Response to Comments Document

Hazardous Waste Listing Determination for Chlorinated Aliphatics Production Wastes (Final Rule)

Figure 1. Comparison of MINTEQ-Generated Kd Values to Literature Values
Manganese -- High End Distribution

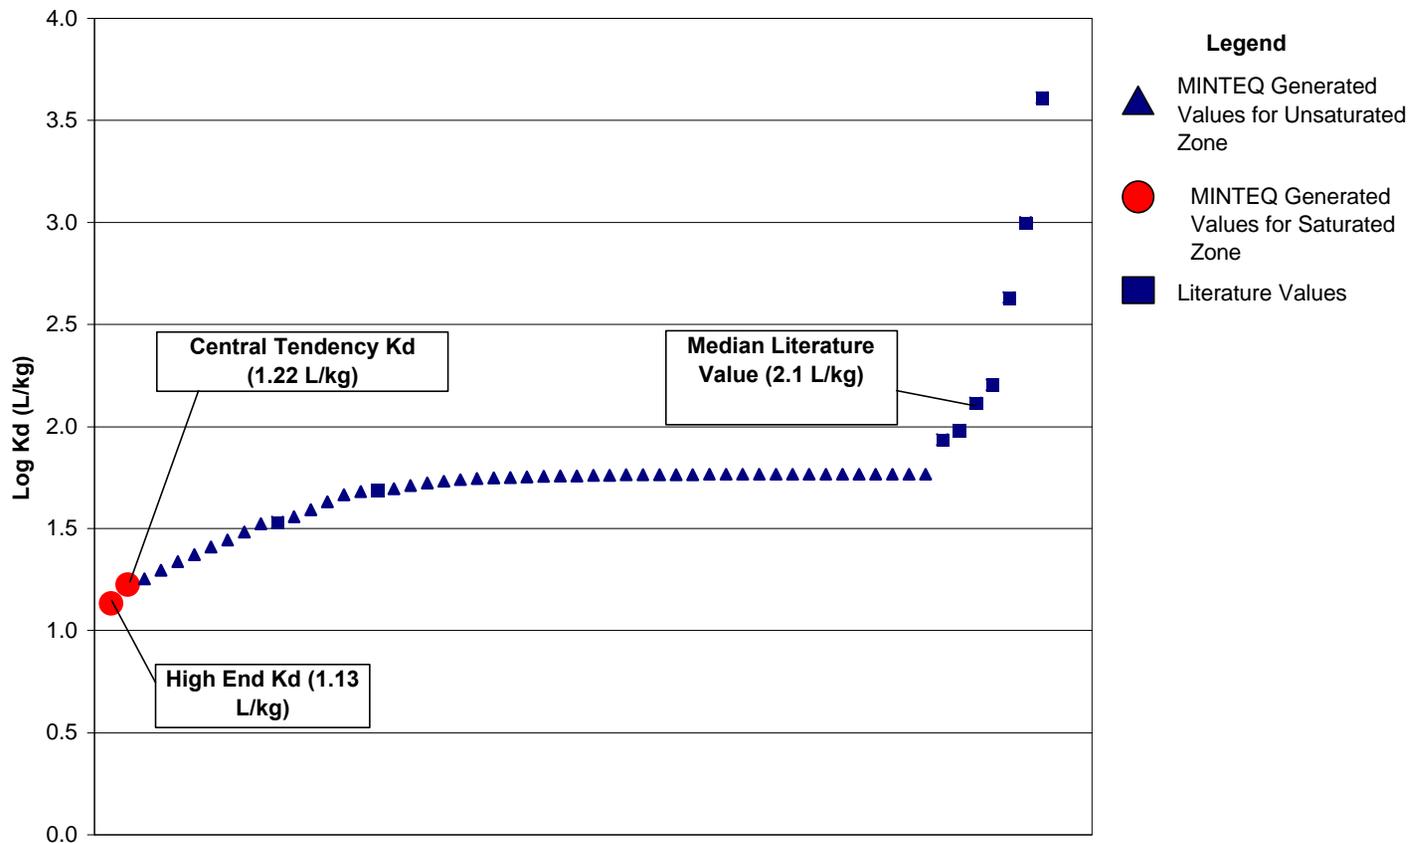
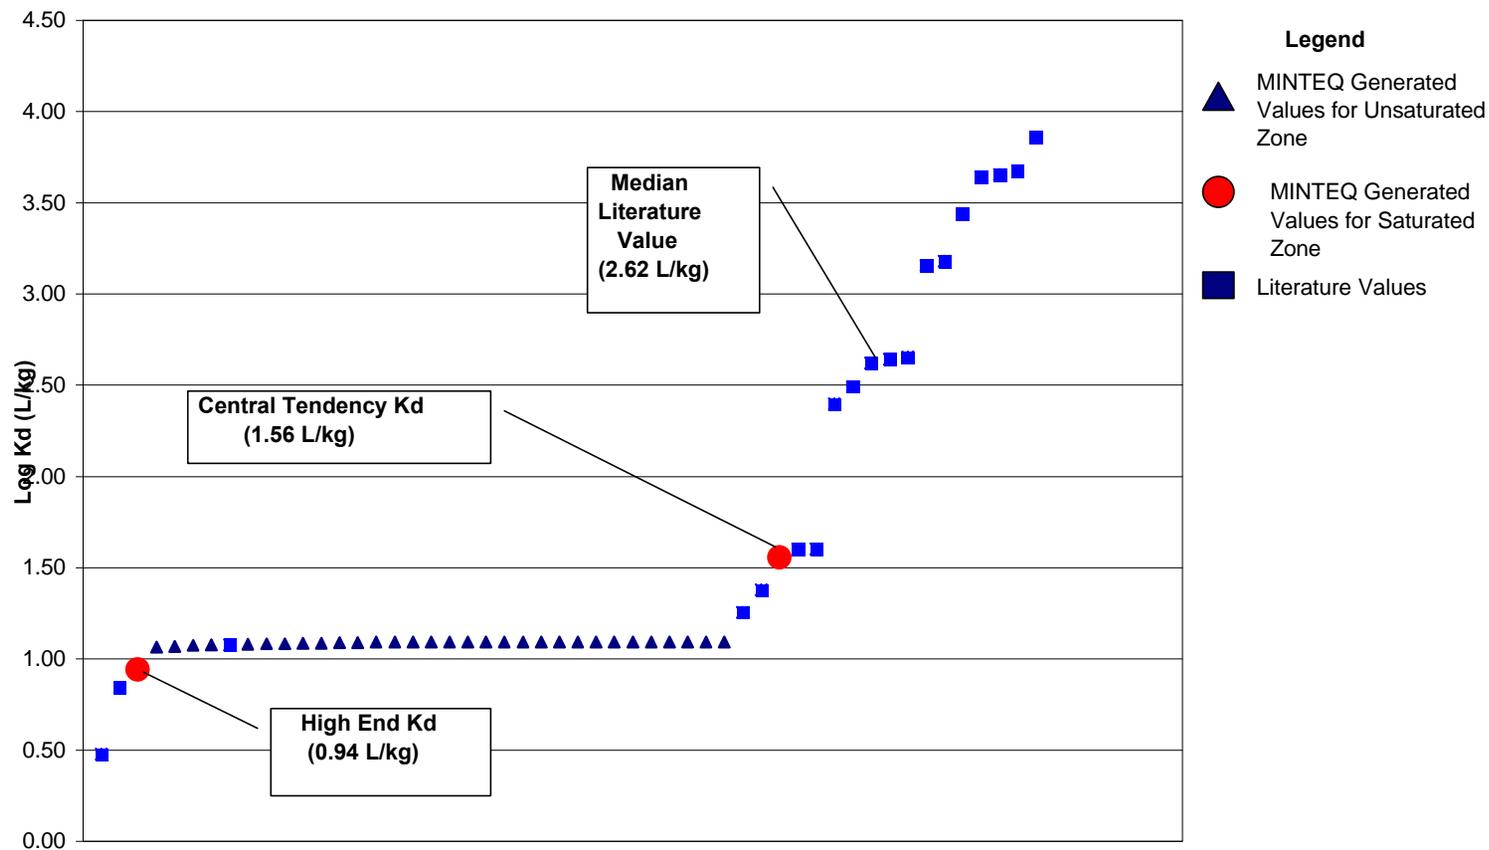
For nickel, the K_d values reported in the literature range from 3 L/kg to 7250 L/kg, with a median value of 420 L/kg. These values represent sand aquifer systems with pH ranging from 5.28 to 8.87. Experimental system parameters are similar to those generally used in model simulations and the two sets of K_d values can be compared. As shown in Figure 2, two of the literature values are less than the range of model-generated values. One literature value falls within the lower end of the range and the majority exceed the model-generated values.

EXHIBIT 13

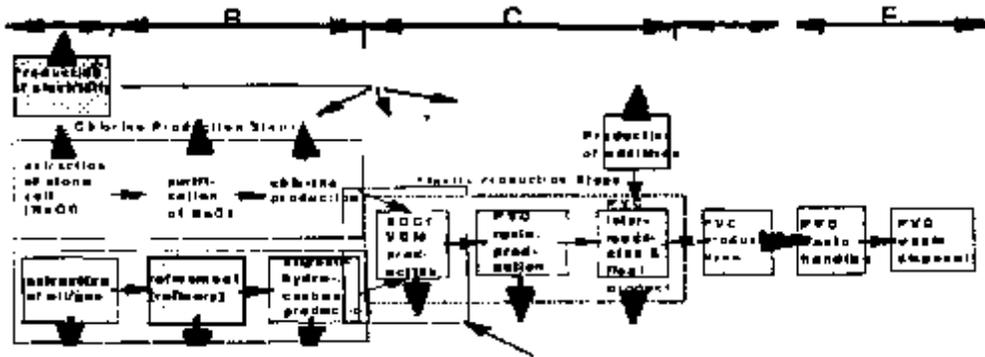
As shown in Exhibit 13 the plastic “process” from which the “listing proposal” waste is generated is the process where chlorine is added to the aliphatic hydrocarbon - the EDC/VCM production unit. Waste from the other plastic production units which include the PVC resin production unit and the PVC intermediates and final production unit are not included in the proposed listing.

EXHIBIT 14

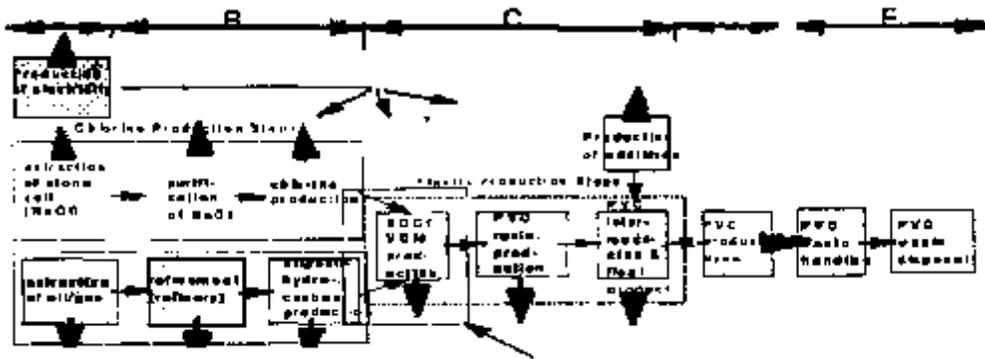
As shown in Exhibit 14 the solvent “process” from which the “listing proposal” waste is generated is also the process where chlorine is added to the aliphatic hydrocarbon - the apply-named Chlorination of hydrocarbons production unit. Waste from the other solvent production units which include the solvent recycling units are not included in the proposed listing.
